**DECISION DOCUMENT**

**TWENTY-SIX NO FURTHER ACTION SITES**

SEPTEMBER 2001

Parsons Engineering Science, Inc  
30 Dan Road  
Canton, Massachusetts 02021

FIGURE 2-1  
 NO ACTION SITES

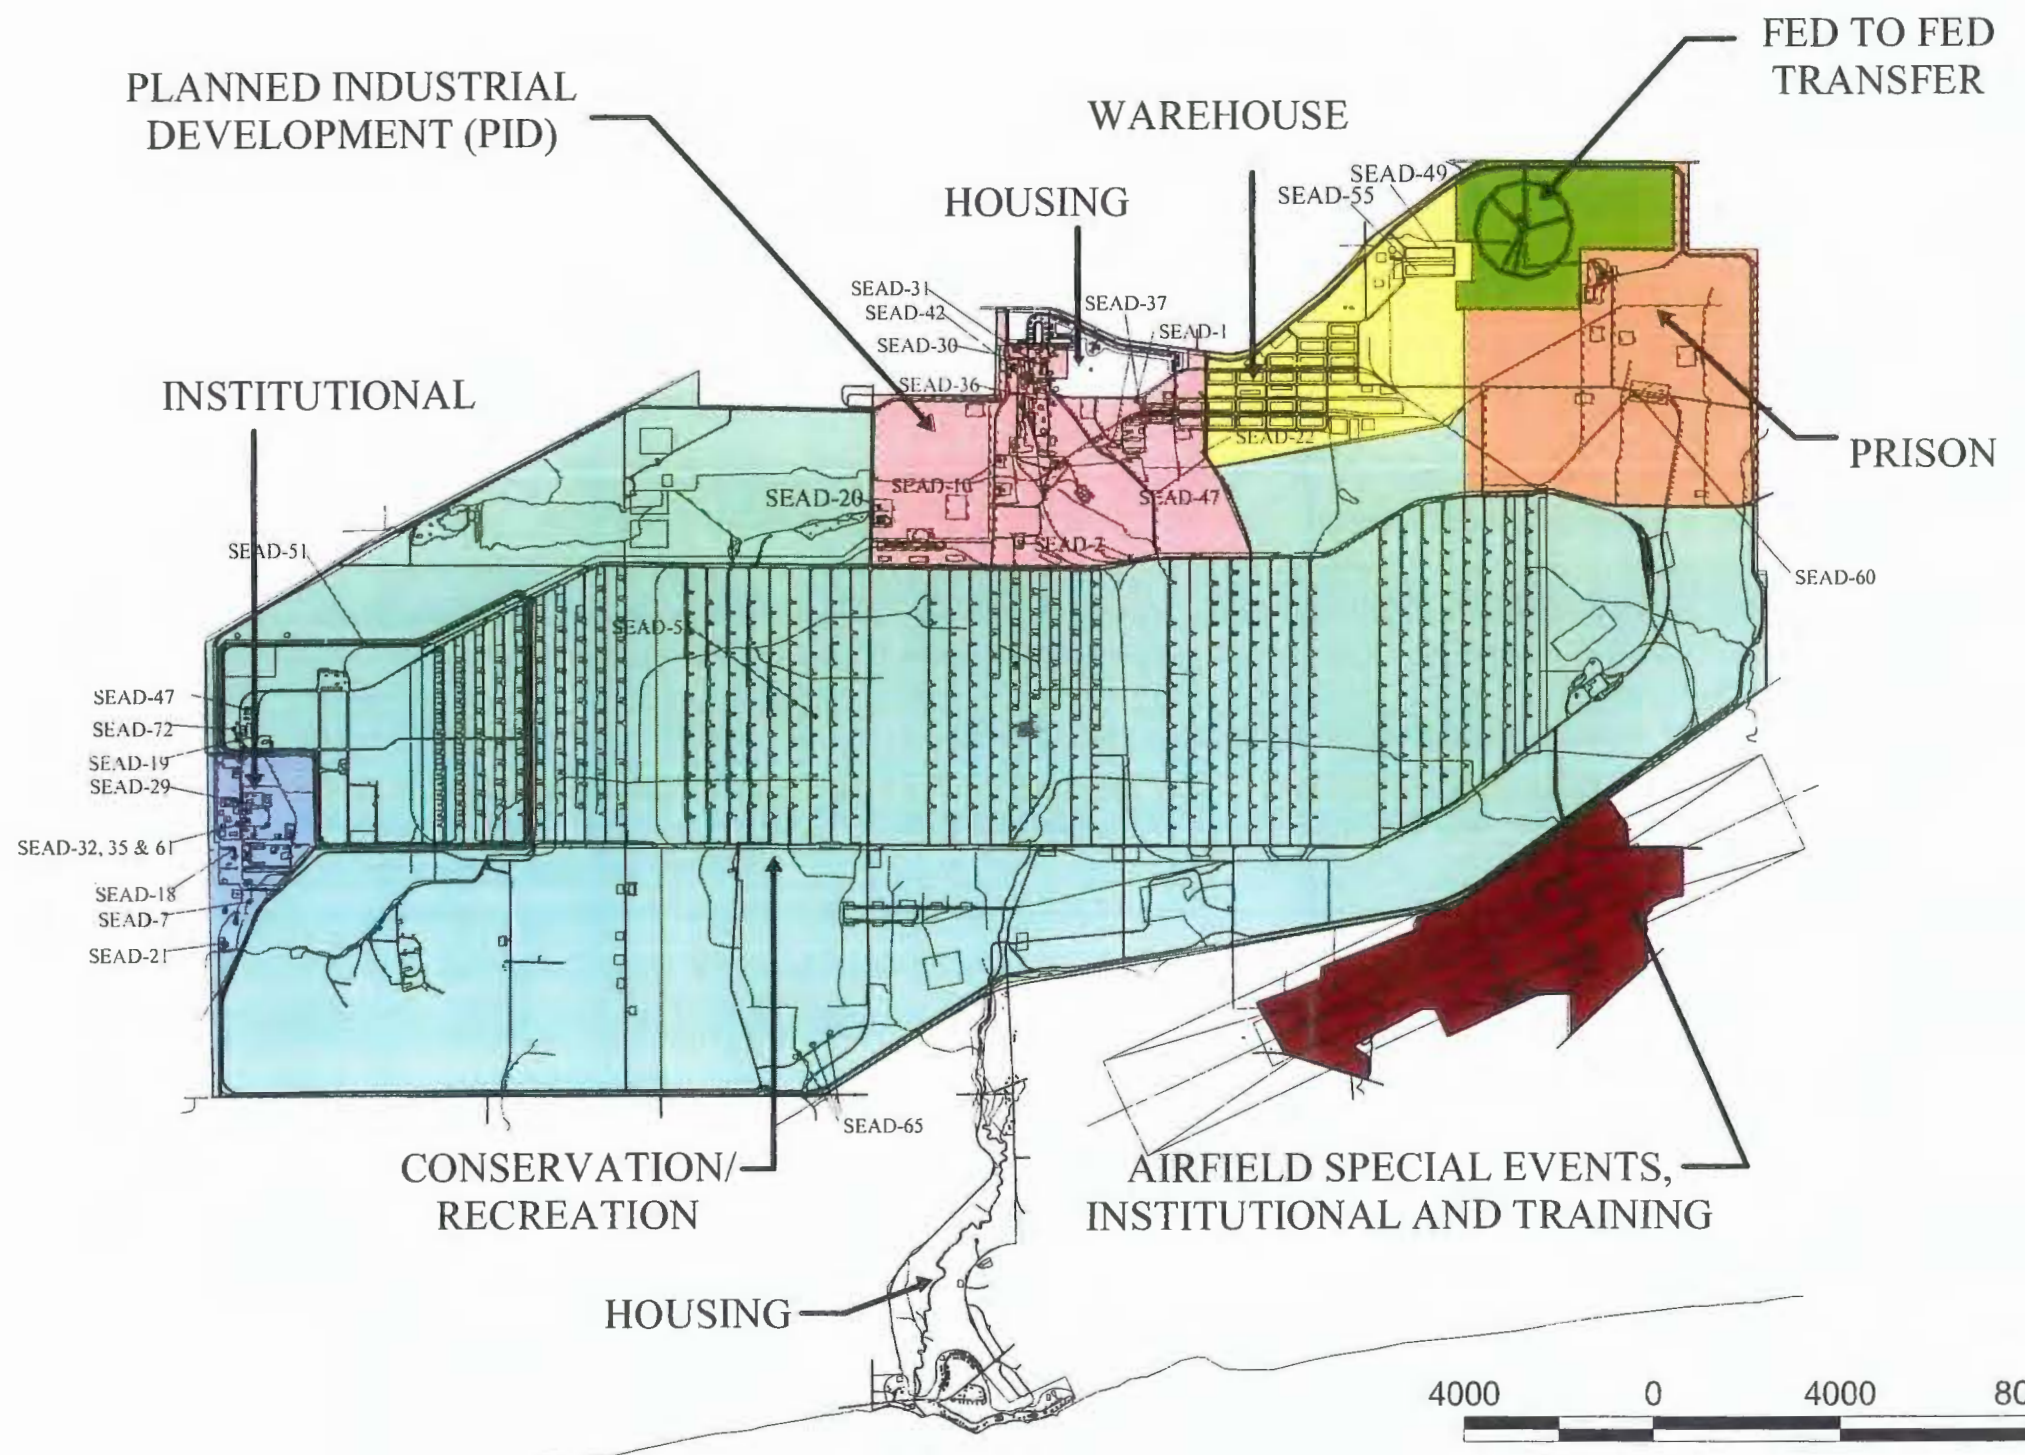
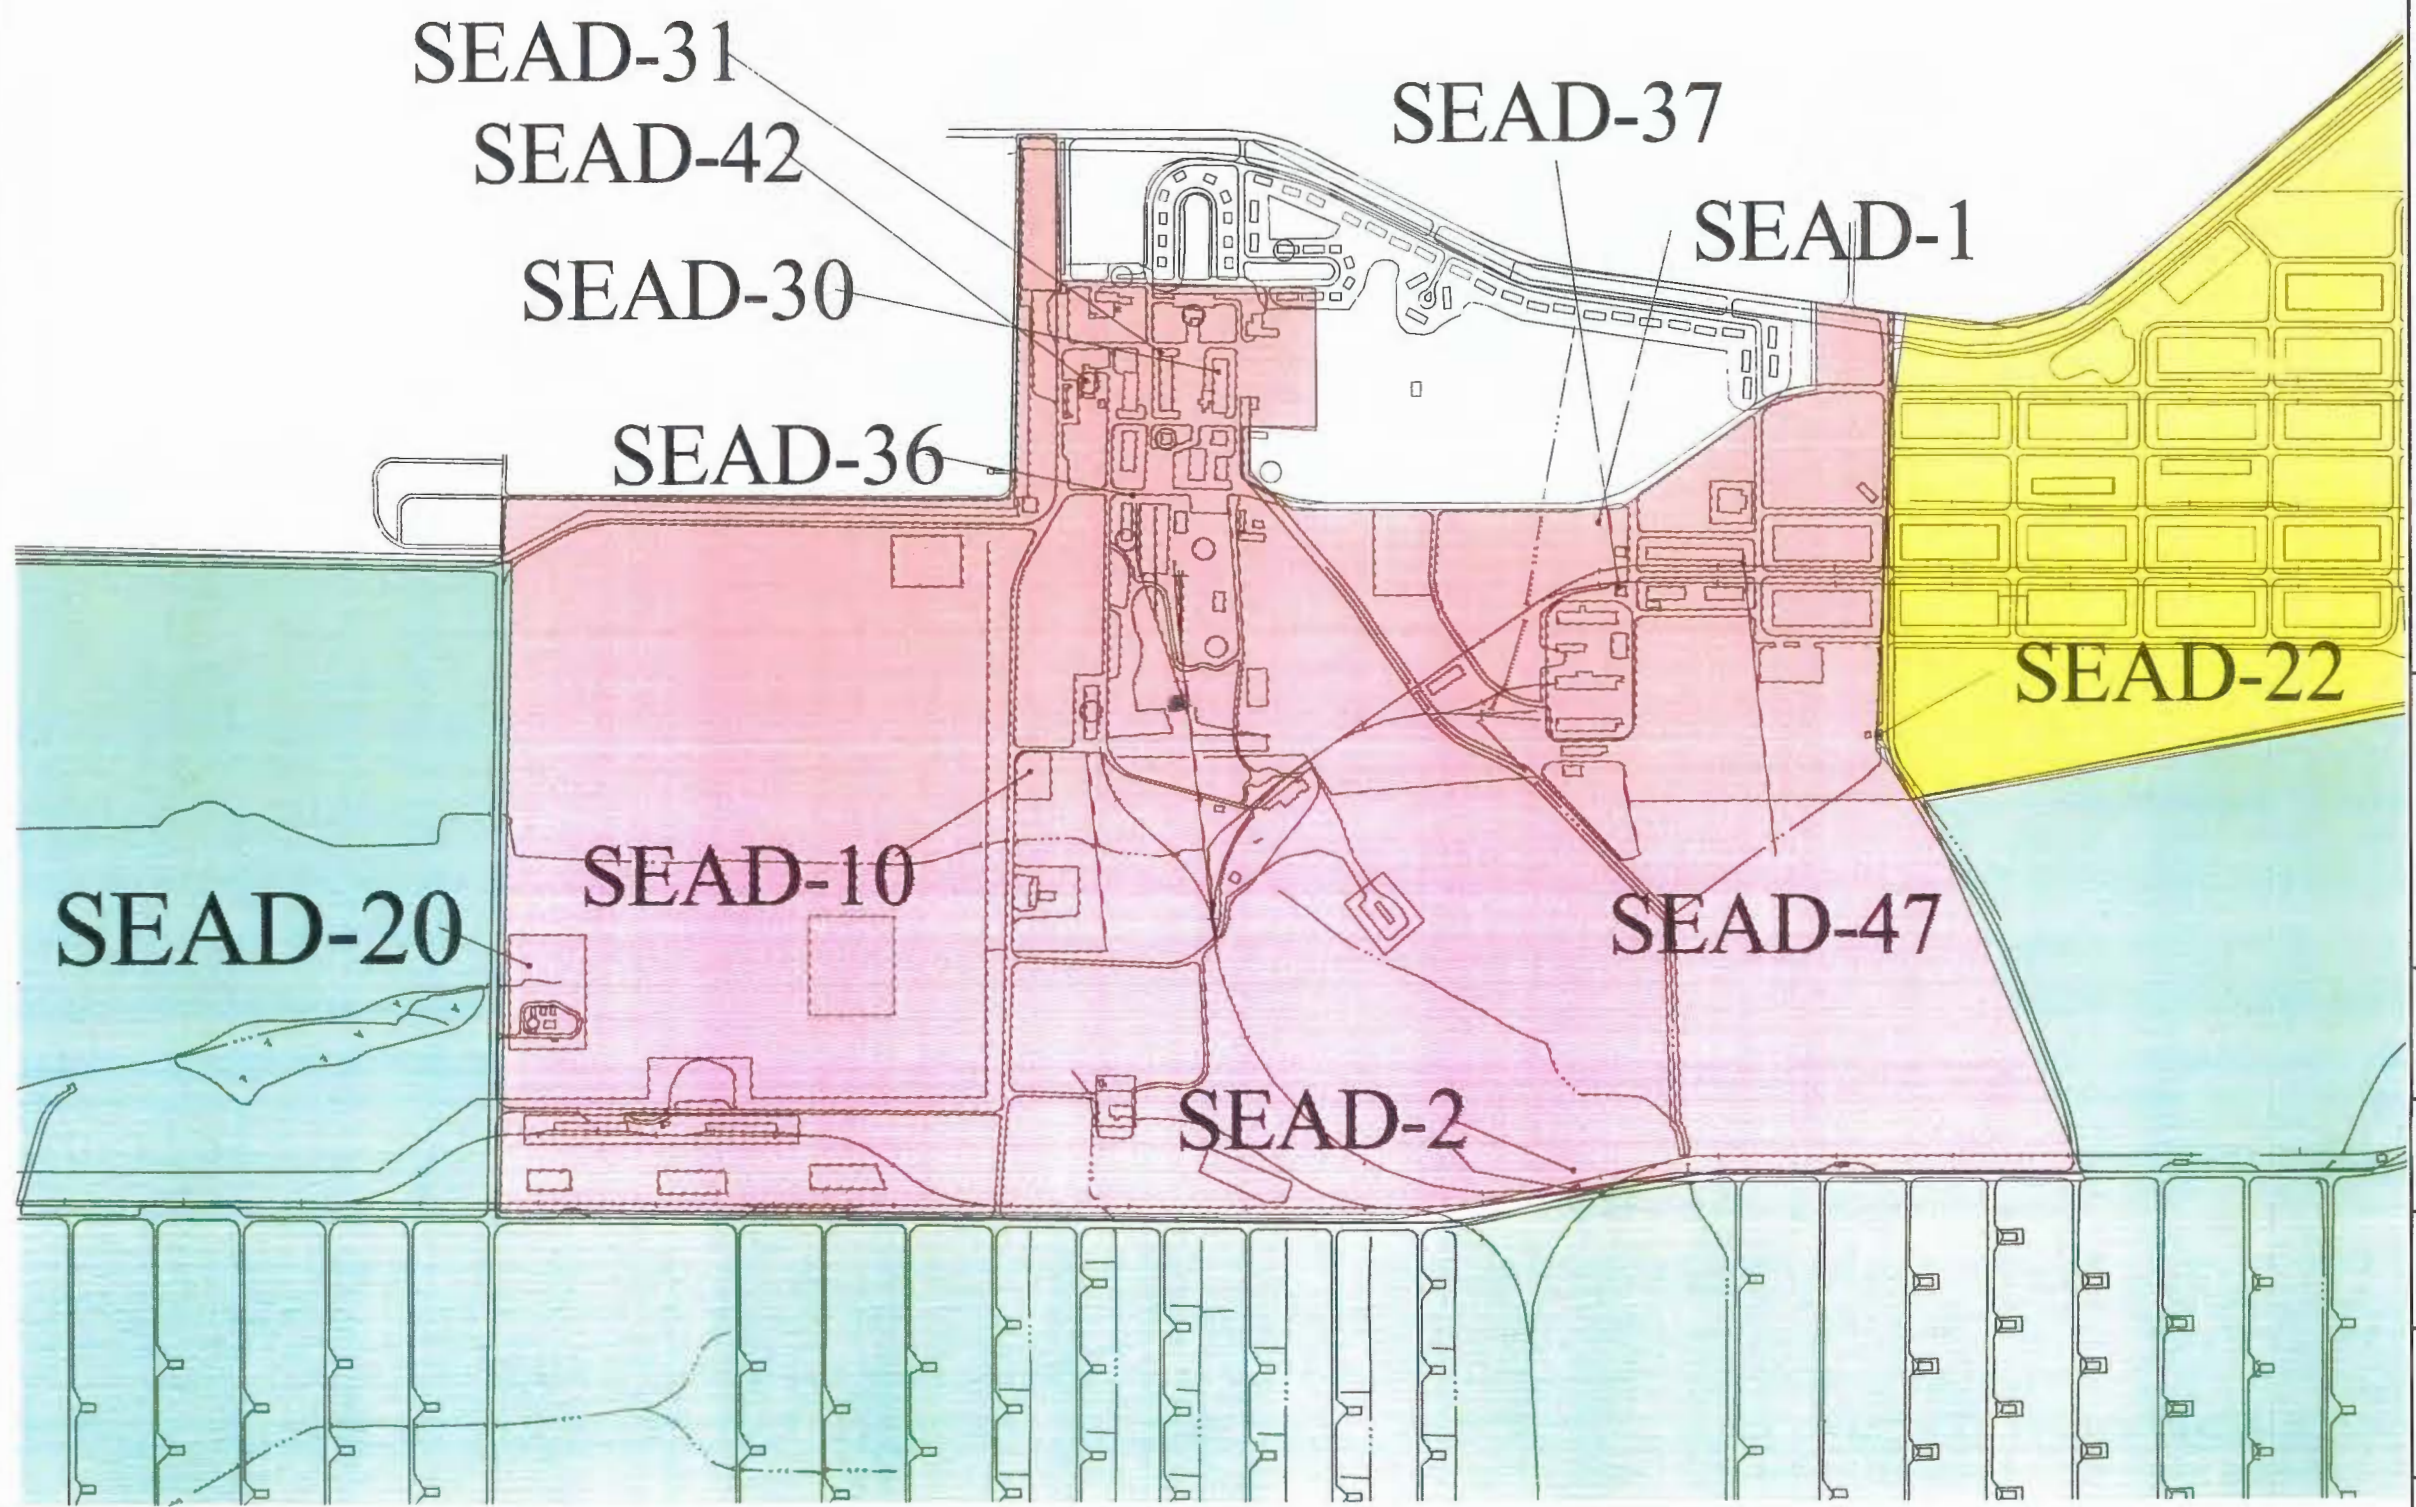
1. There seems to be a typographical error on the number for the first figure of Chapter 2. Referenced Figure 2-1 cannot be found in the document. Please include more specific maps for the different areas (i.e.. North End, PID, Warehouse, Q, etc.).
